STERLING RANCH FILING 5

PUD PRELIMINARY PLAN AMENDMENT

V1_PUD Development Plan - REVIEW 1.pdf Markup Summary

LOT TYPICALS

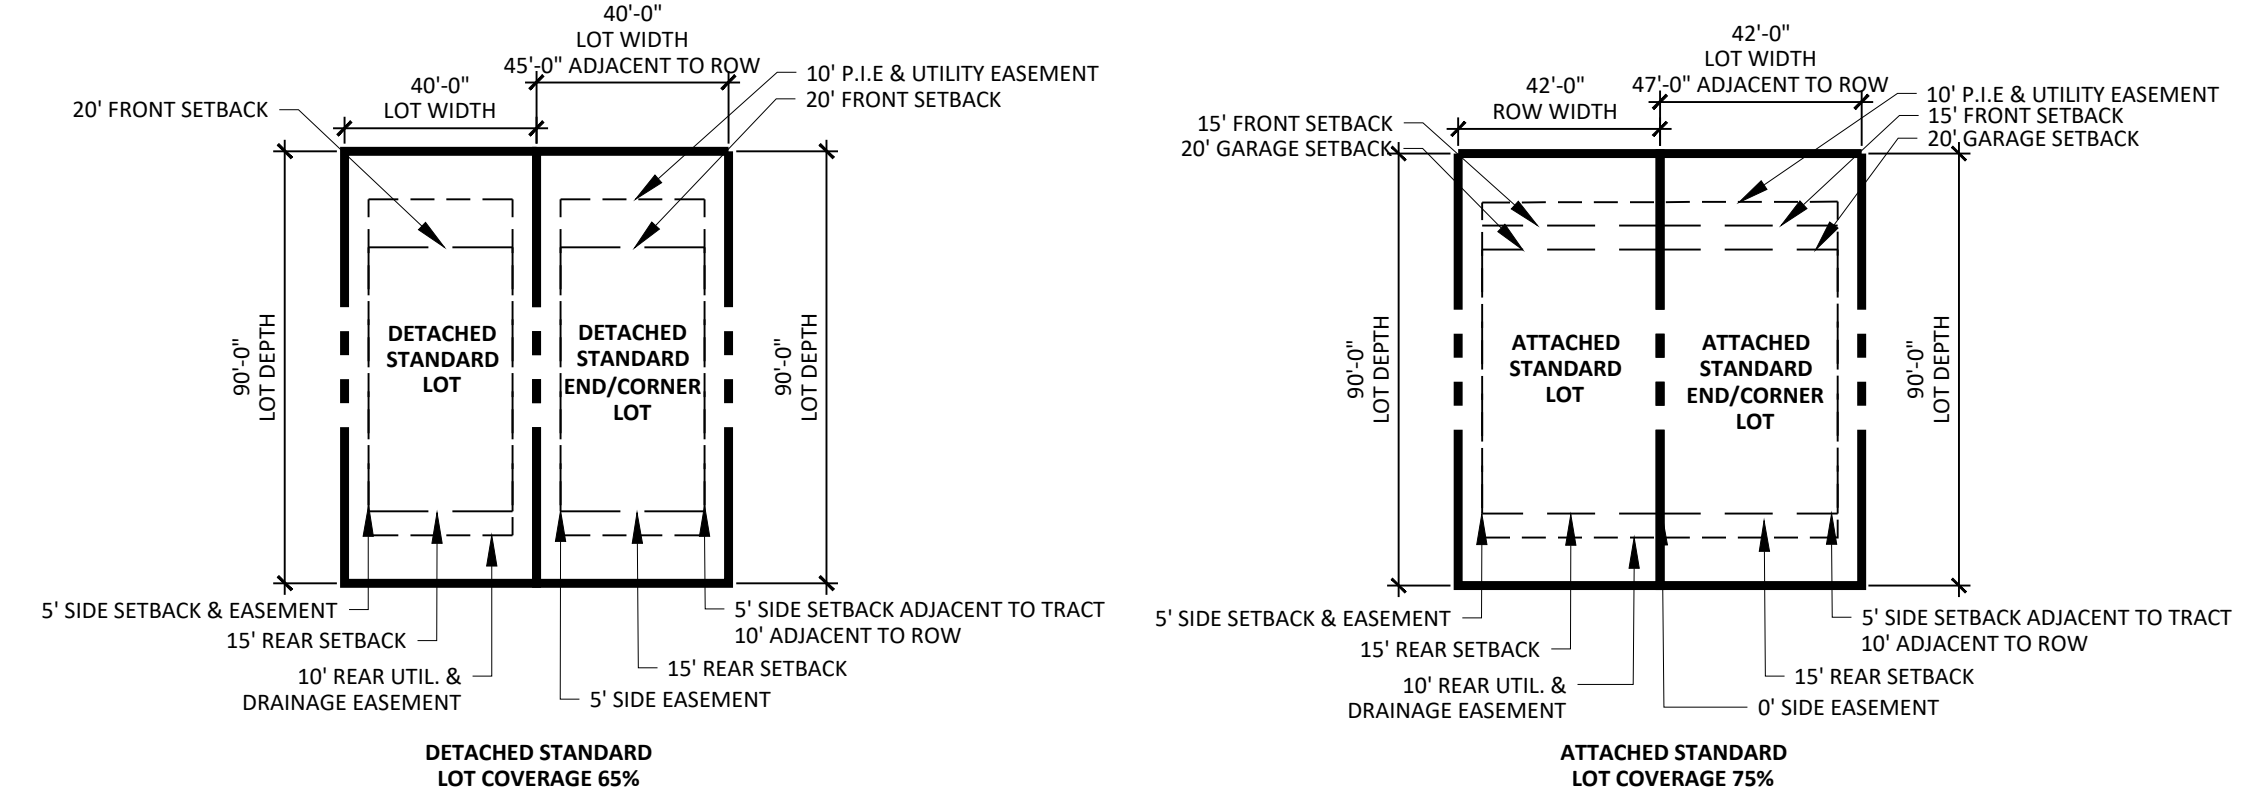
lots have different setbacks please add dimensional standards for specific lots

cloud the changed dimensions

lots have different setbacks please add dimensional standards for specific lots

PUD PRELIMINARY PLAN

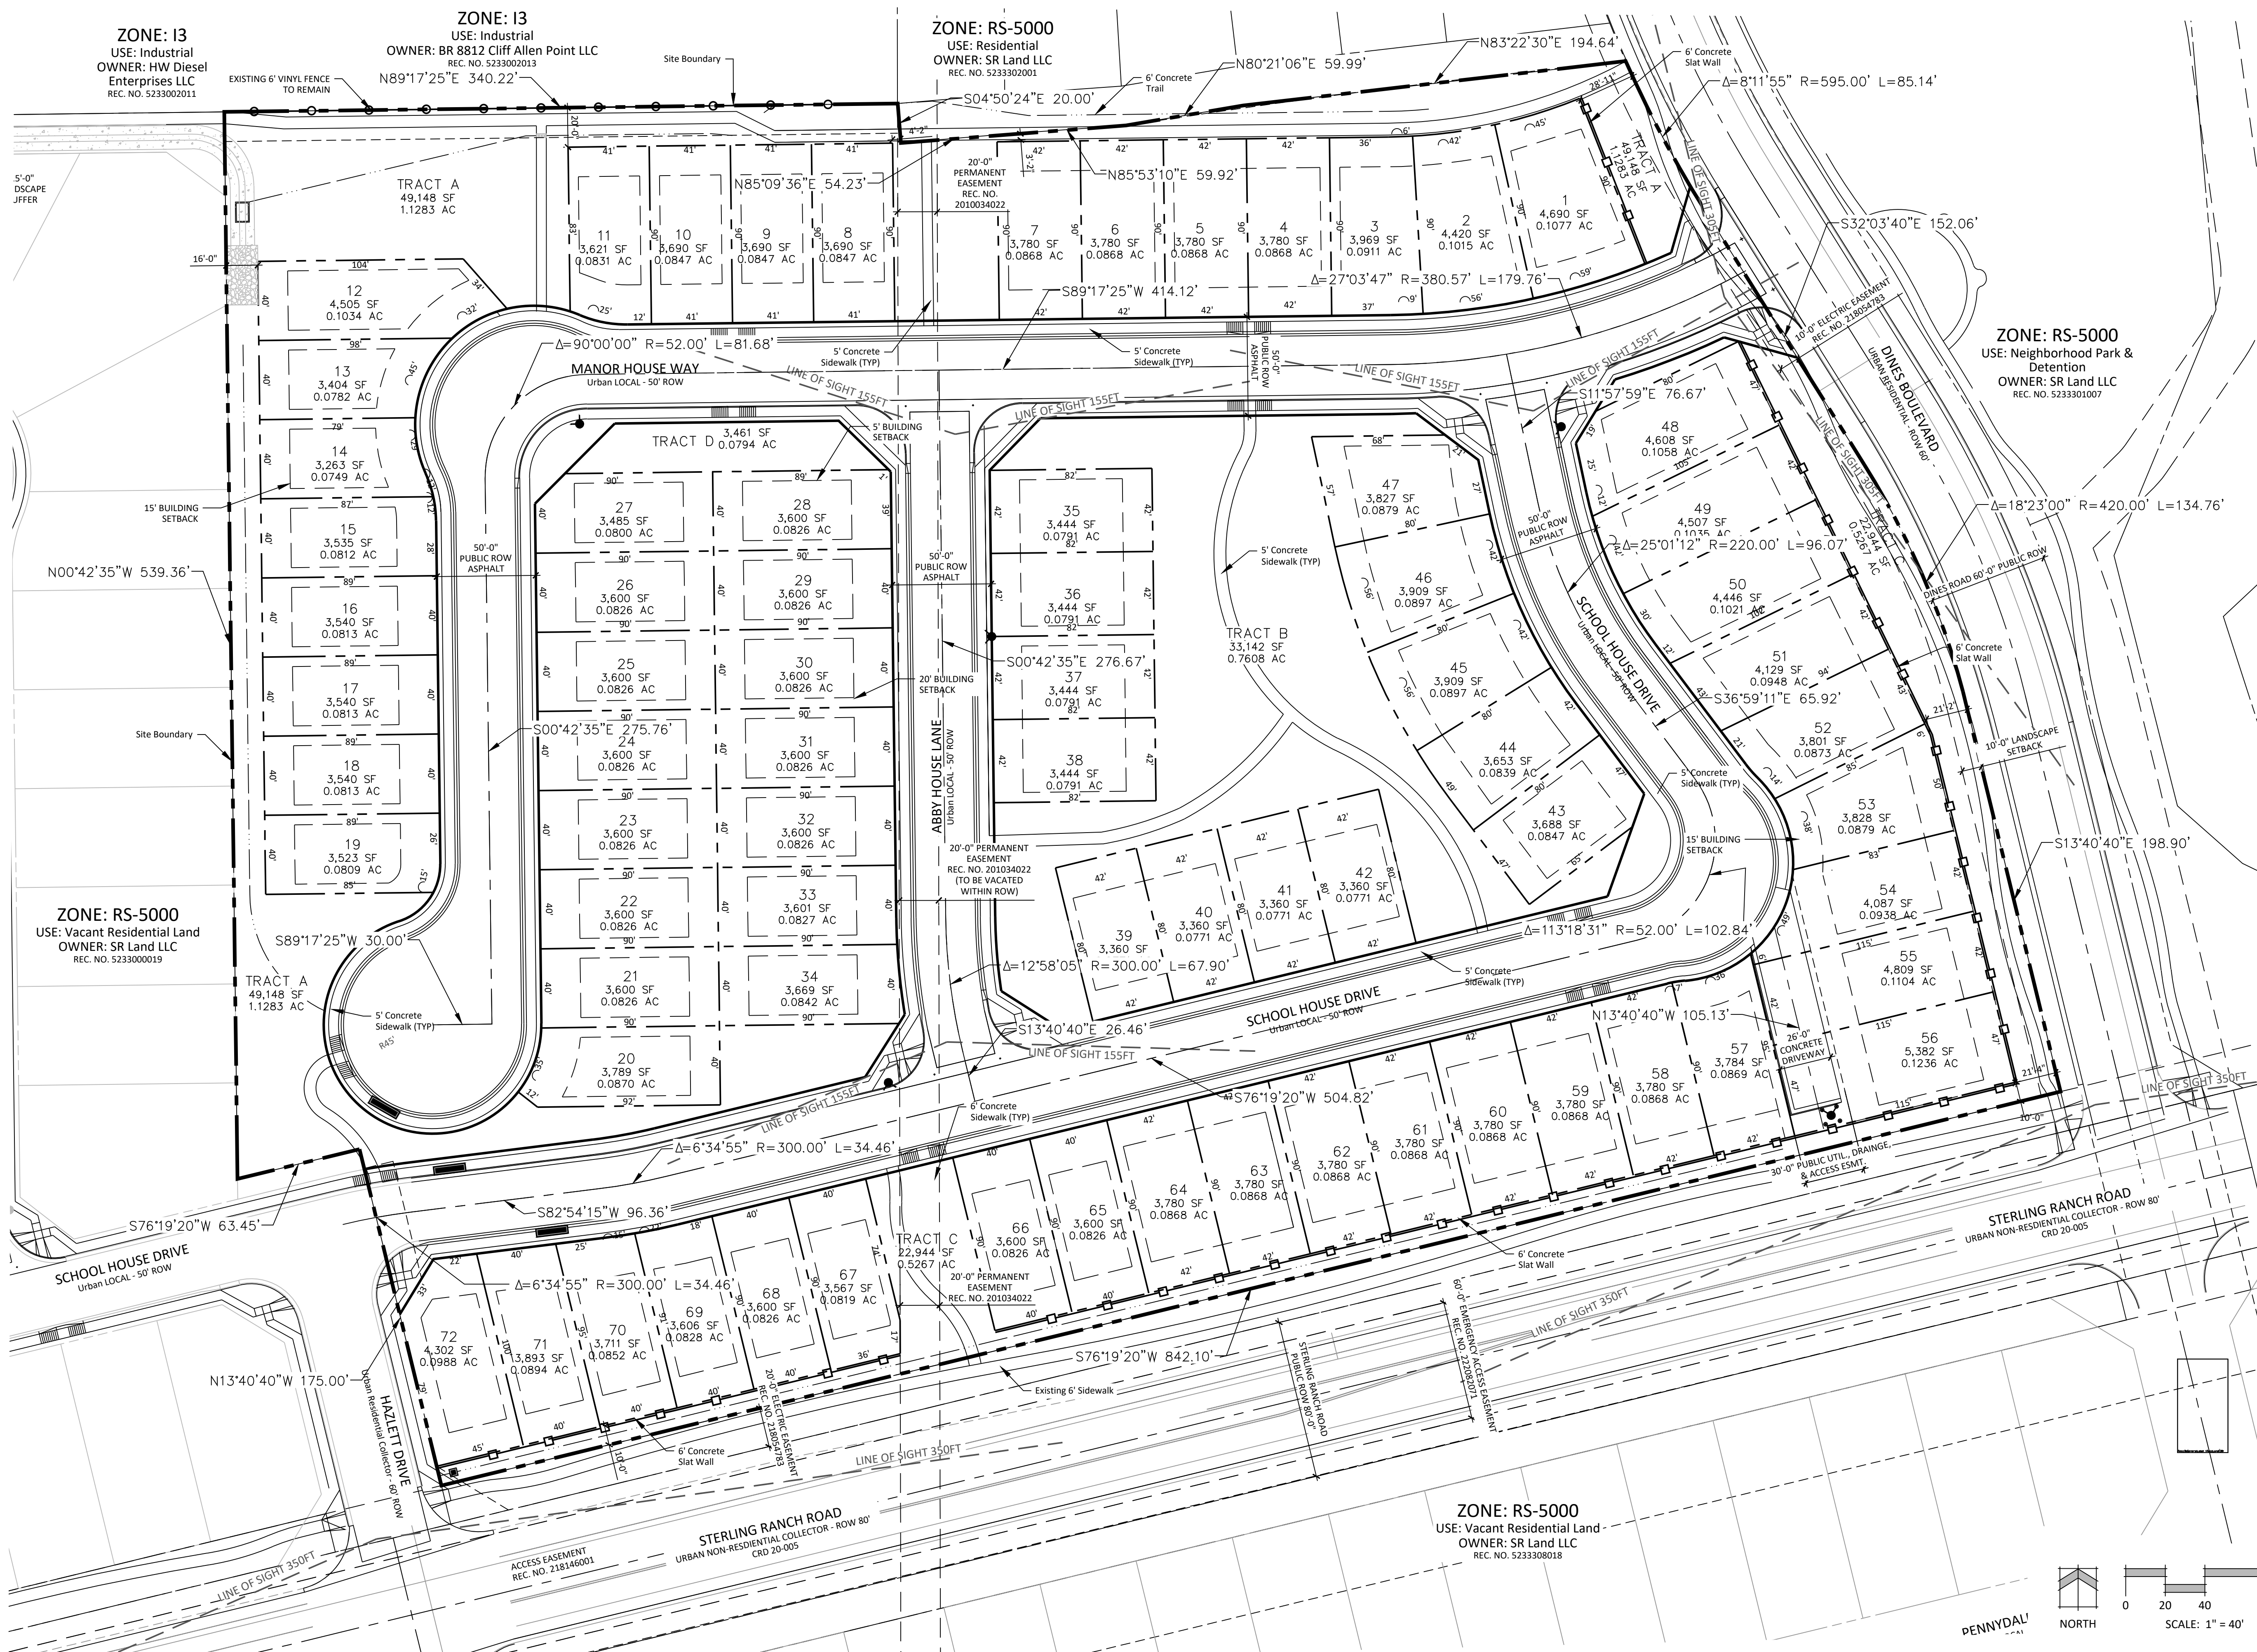
MINOR AMENDMENT
